Commonwealth Edison
One First National Plaza, Chicago, Illinois
Address Reply to: Post Office Box 767
Chicago, Illinois 60690*

Subject: LaSalle County Station Unit 1
Proposed Amendment to NPF-11
Change Request NPF-11/82-10
Supplemental Information
NRC Docket No. 50-373

LA SALLE COUNTY
ECCS PRESSURE INTERLOCK REVISION

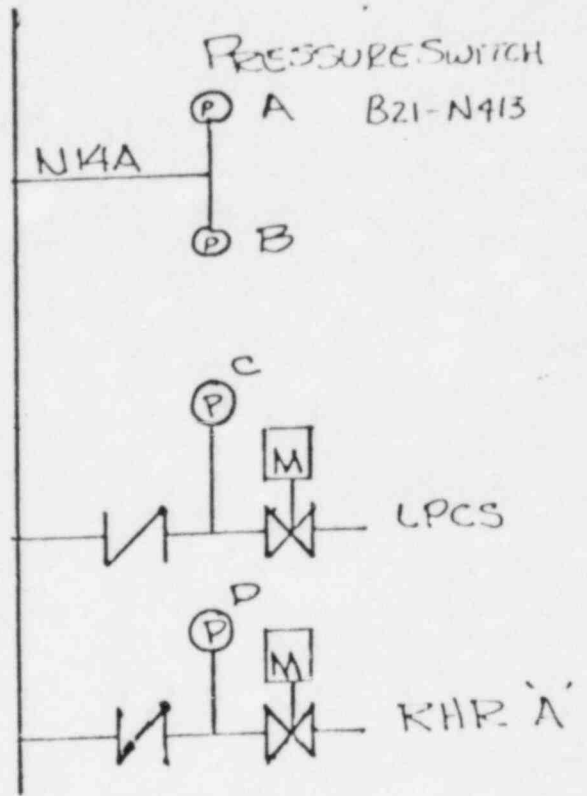
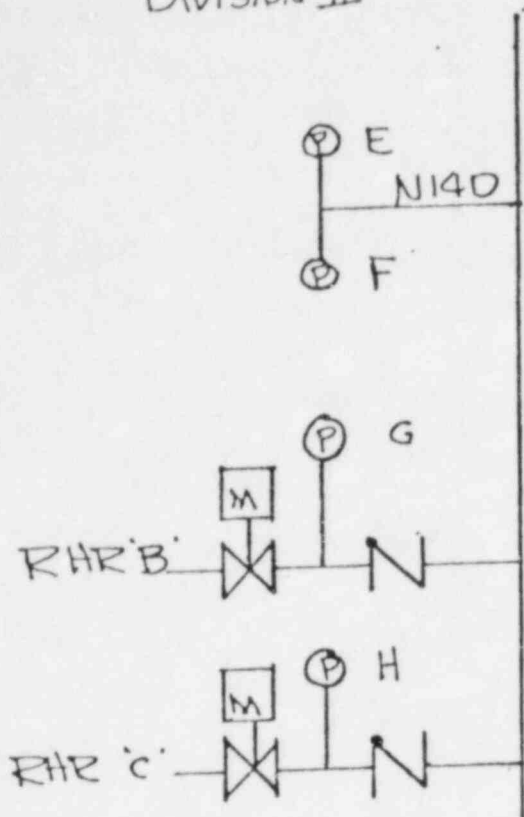
Upon review of the above scenario, Commonwealth Edison personnel developed a revised logic. The attached sketches confirm the revised logic for the pressure interlock on the low pressure ECCS's at LaSalle. This interlock at $500 + 20$ psia replaces the prior differential pressure permissive which the NRC rejected during SER reviews.

The sketches indicate physical separation of the instrument sensing lines for the replacement pressure switches. This prevents satisfying the interlock logic in a single electrical division by a single sensing line failure. The LPCS, and each of the three RHR loops, has a dedicated pressure sensor whose signal (on low pressure) closes a series switch in the interlock logic. The other series signal to complete the logic and open the interlock is either or both pressure sensors mounted on instrument 14A. As indicated on the sketch and explained in the reference telecon, the logic is (1:2 plus 1:1) duplicated in redundant electrical divisions corresponding to the ECCS electric power divisions.

The sketches also indicate that the former annunciation contacts from the differential pressure permissive are now utilized for this ECCS low pressure interlock annunciation via K8. The annunciation that the low pressure interlock condition has been met is adequate operational information because the injection valve and system parameters for each low pressure ECCS independently confirm successful ECCS operation.
